Limerick Generating Station, Units 1 and 2
Facility Operating License Nos. NPF-39 and NPF-85
NRC Docket Nos. 50-352 and 50-353

Subject: Response to Request for Additional Information Concerning Relief
Requests Associated with the Second Inservice Inspection (ISI) Interval

**Response to Request for Additional Information
Regarding Relief Requests Associated With the
Second Inservice Inspection Interval**

Limerick Generating Station, Units 1 and 2

Unit 2 Vessel Nozzle and Weld Locations

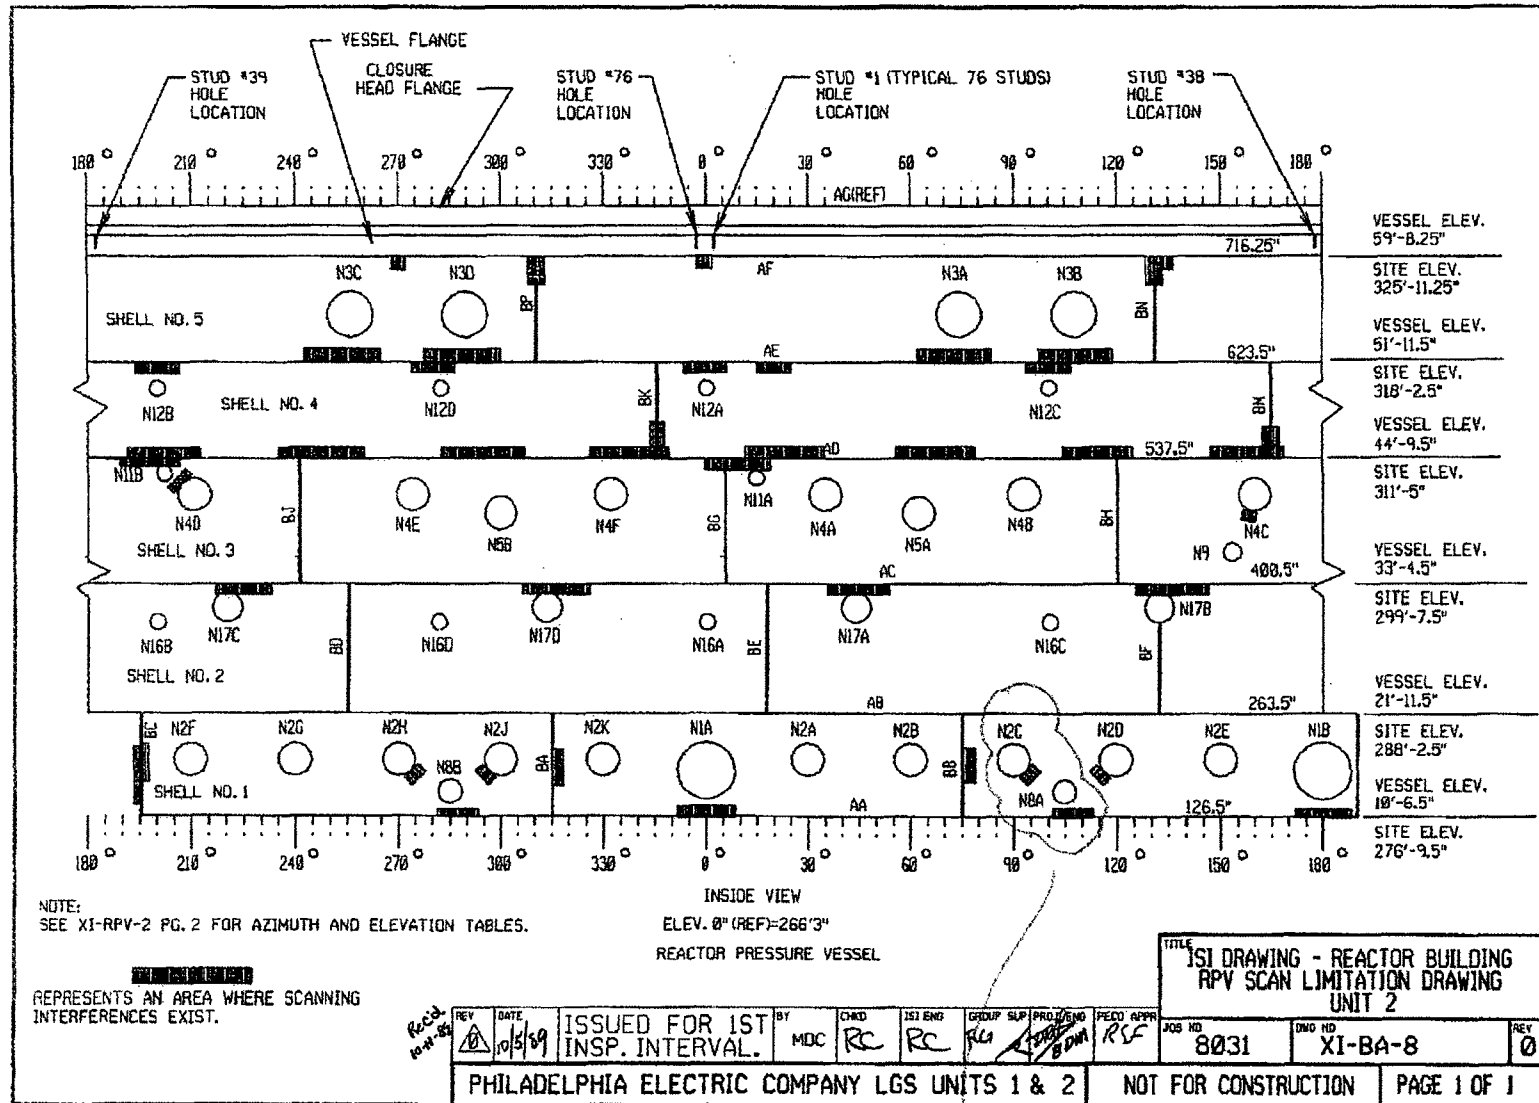
The location of the N18A nozzle limits the examination of the N12C nozzle.

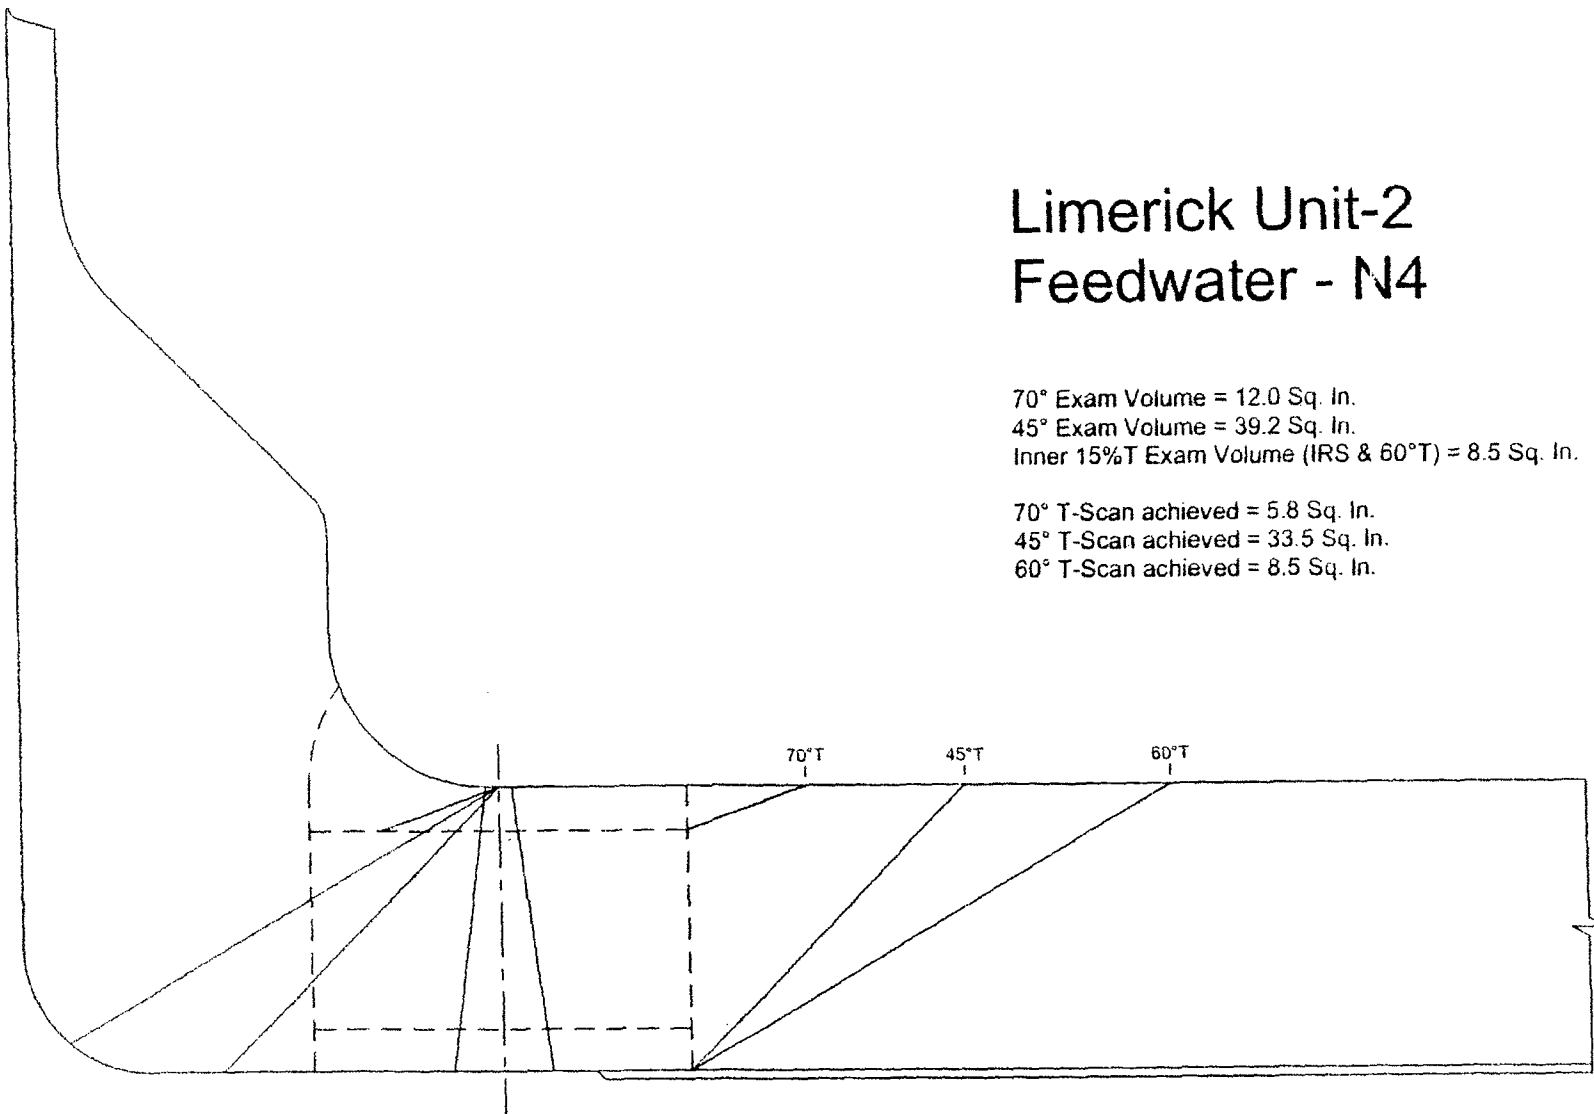
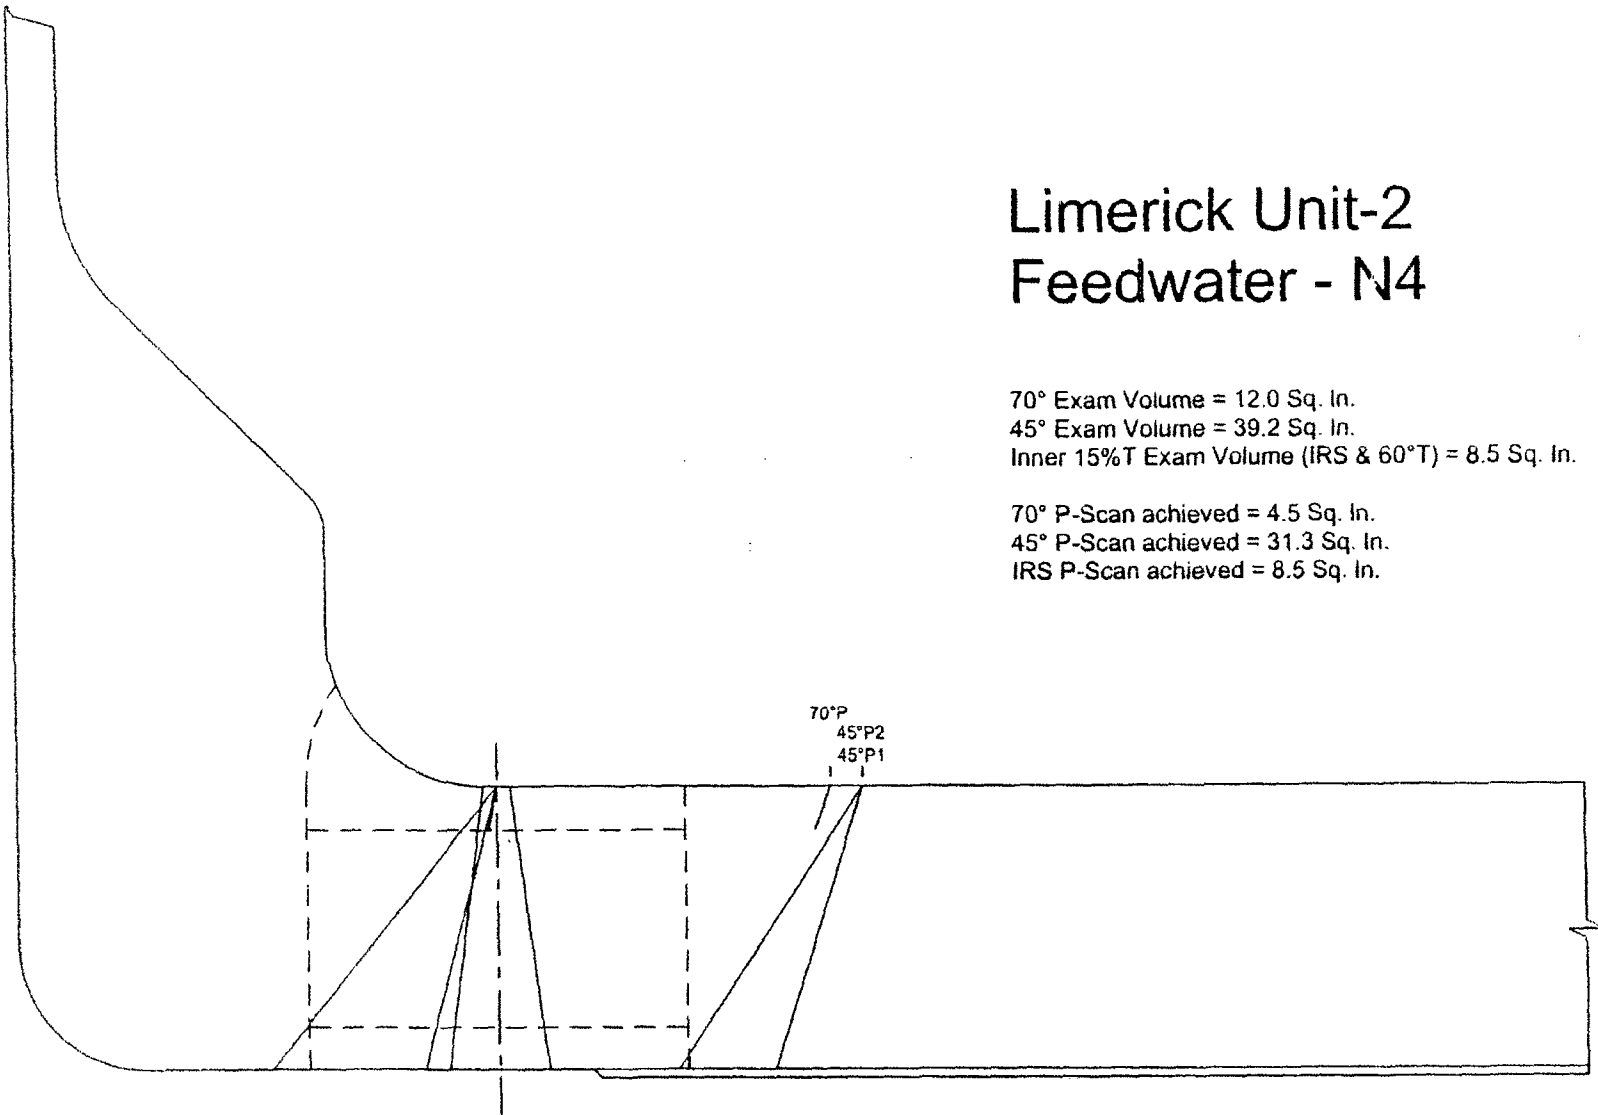
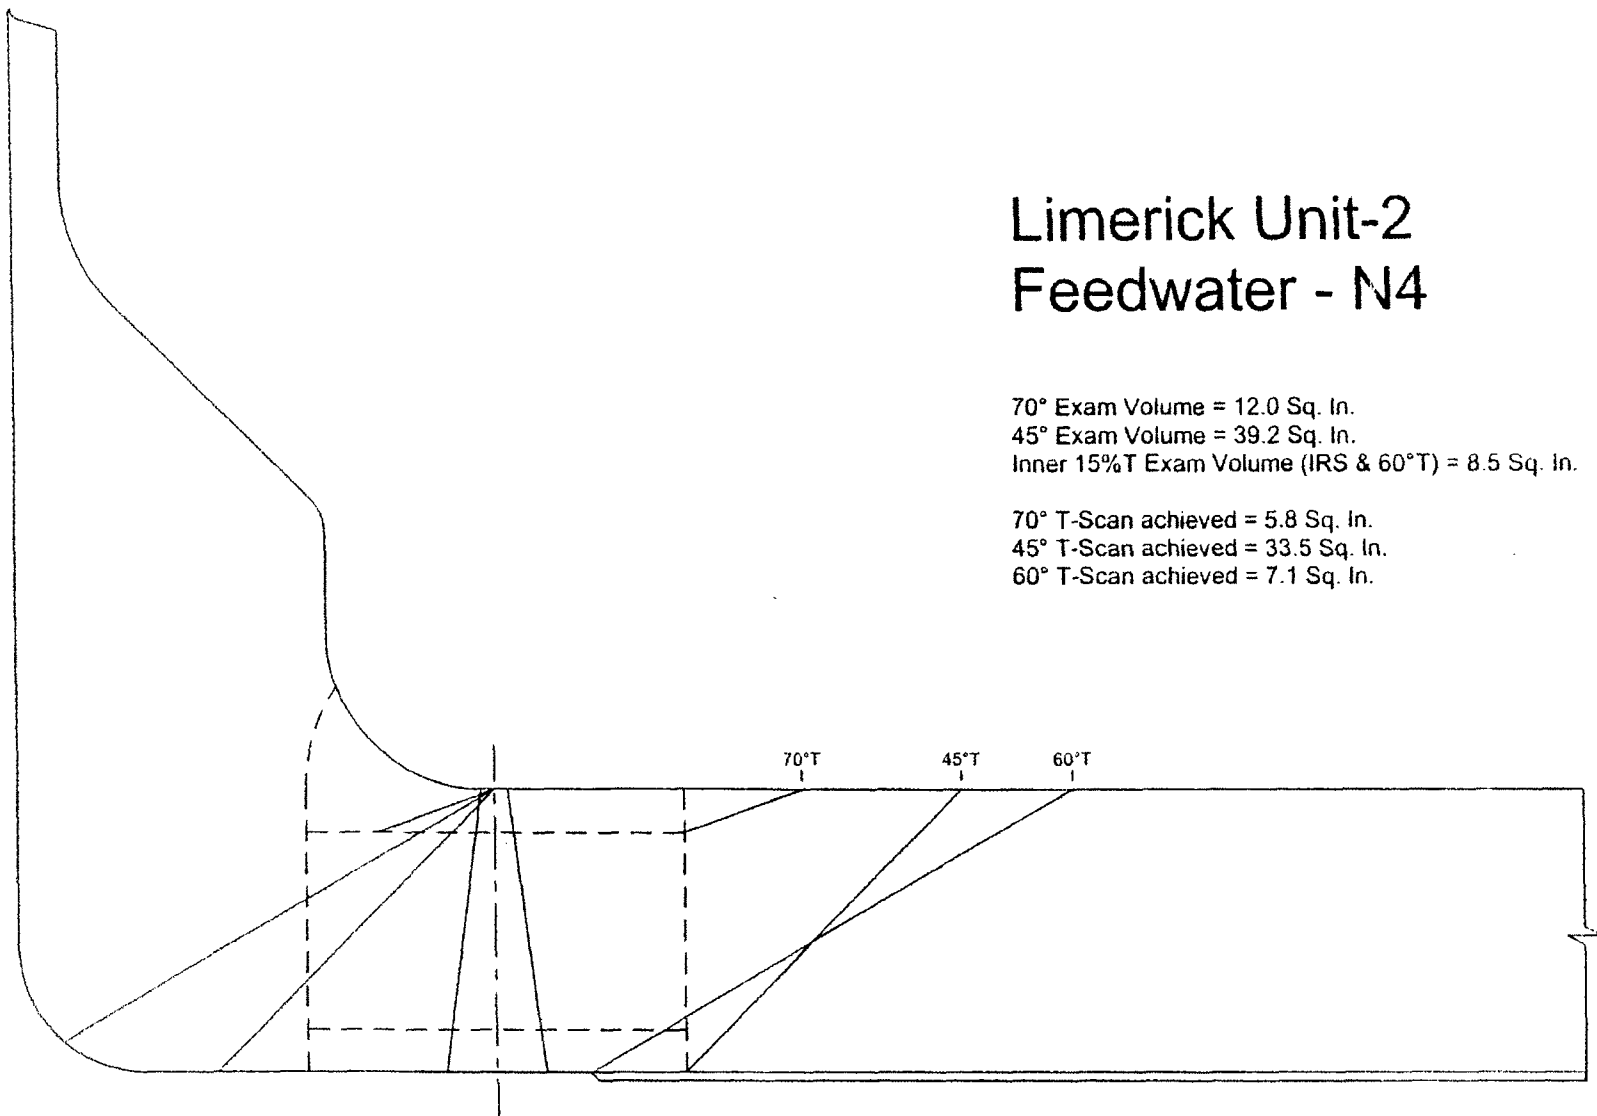
Comments: A - Examined 360°. Scanning limited due to nozzle configuration and N9 nozzle.
B - Examination area was limited due to N9 nozzle.

Unit 2 Vessel Nozzle and Weld Locations

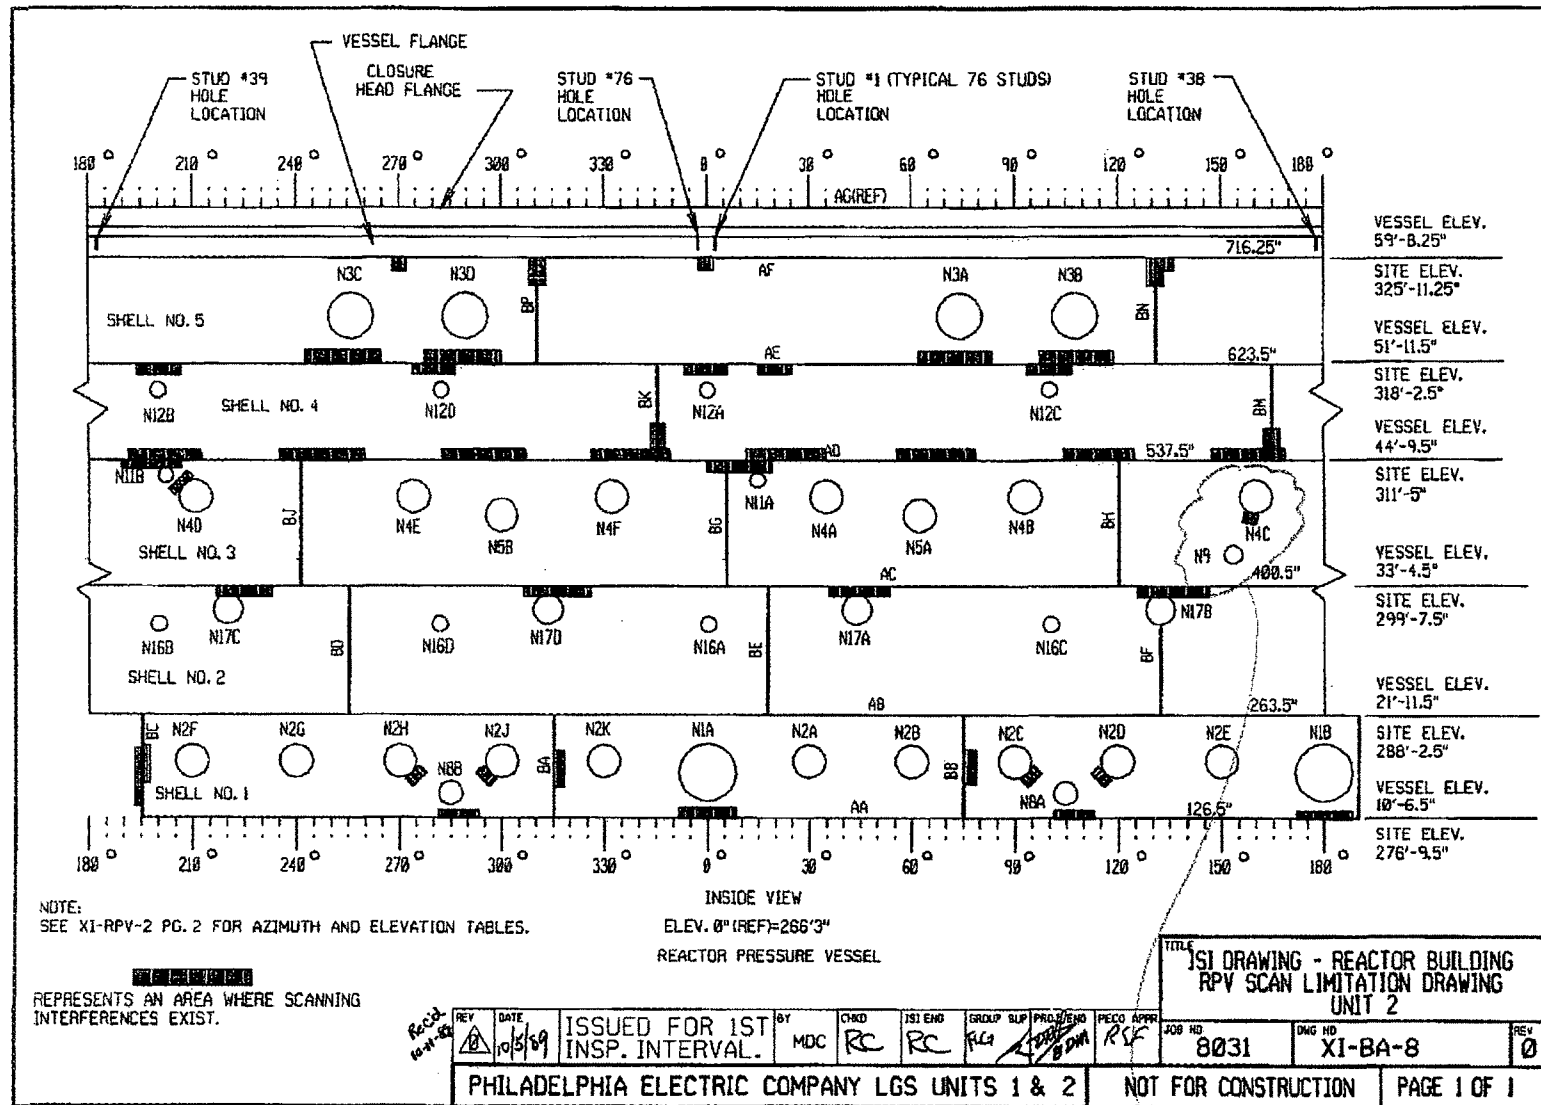
The location of the N1P nozzle limits the examination of the N1Q nozzle
